Office Action Summary

10/772,226

TATE ET AL.

DETAILED ACTION

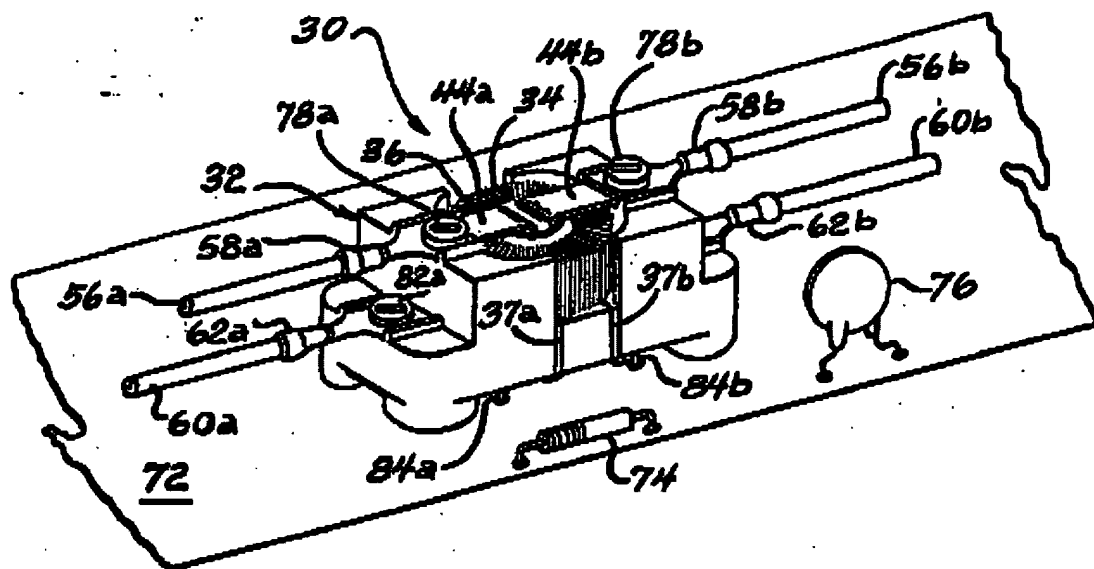
2. Claims 13-14, 17 are rejected under 35 U.S.C. 102(b) as being anticipated by Brodzik et al. [4748405].

- a current transformer having a core 36, first coil 34 in flux inducing relationship with the core; the core including an opening defining a void [center of the core];
- first current coil 44a passing thru the void;
- a second current coil 44b passing through the void;
- an insulation member 40 [up-raised center portion of the mounting block 32 of durable plastic material] disposed between the first current coil and second current coil, the insulation member structurally separate from the first current coil to the second current coil [see figure 3; col 3, lines 7-25].
- The insulation member extend thru the void, and has a width exceeding a width of second coil;
- The conductors are un-insulated conductor passing the void;
- The first and second current coils are un-insulated metal bars [figures 2-3].

includes a pair of facing curvilinear slots 38a and 38b positioned on an upper portion thereof and forming a generally circular recessed portion therein. The pair of curvilinear slots 38a, 38b is adapted to receive and support the combination of a donut-shaped ferrite core 36 and a toroidal coil 34 wound around the ferrite core. With the combination toroidal coil/ferrite core positioned within the curvilinear slots 38a, 38b in the upper portion of the mounting/connecting block 32, an upraised center portion 40 of the block is positioned within the ferrite core's aperture. Positioned within the upraised center portion 40 of the mounting/connecting block 32 and extending downward to the lower surface thereof are a pair of slots 42a, 42b. Each of the slots 42a, 42b is adapted to receive a respective conductor 44a, 44b which are each in the form of a metal strip or bus bar in a preferred embodiment. Each of the metal strip conductors 44a, 44b is initially L-shaped and includes respective pairs of apertures 50a, 50b and 52a, 52b positioned on respective ends thereof. With the generally vertically oriented portion of each of the metal strip conductors 44a, 44b positioned within one of the mounting/connecting block slots 42a, 42b, the generally horizontally oriented portion of each of the metal strip conductors is positioned parallel and immediately adjacent to the lower surface of the mounting/connecting block 32.

FIG. 5**FIG. 4**

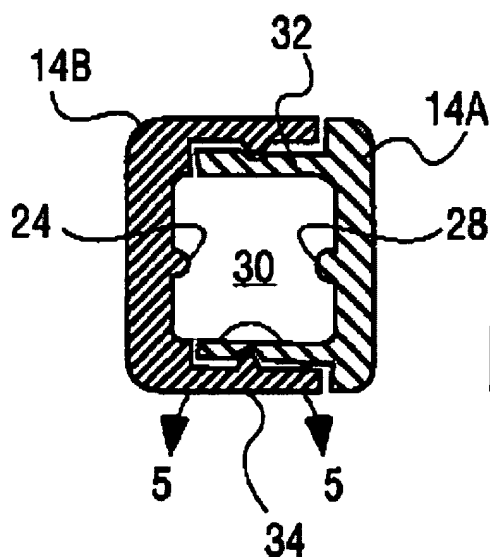
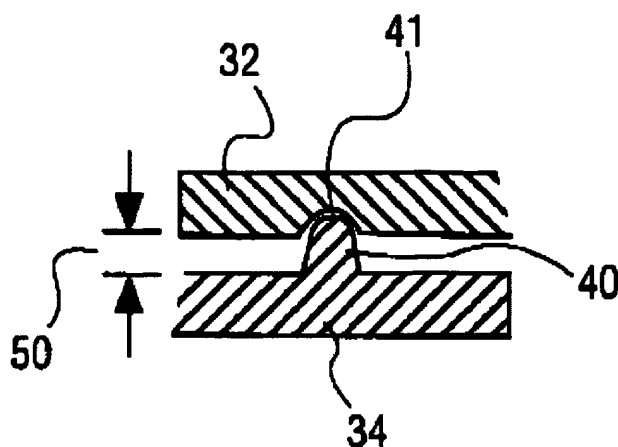
With respect to claims 5-7, Baumann discloses first and second annular cup shape having rib 40 disposed about the inside surface of wall 34 of cup 14b and engages a groove 41 disposed about the outside wall 32 of cup 14a which provides snap fit features as shown in figures 4-5.

Additionally, a rib 40 is disposed about the inside surface of wall 34 of the cup 14b and engages a groove 41 disposed about the outside surface of wall 32 of the cup 14a. The rib 40 is taller than the depth of the groove 41 leaving an air gap 50. This provides a partial air dielectric along the sides of the core when used in conjunction with the ribs 24 and 28. In one embodiment the air gap 50 is approximately 2 mm.
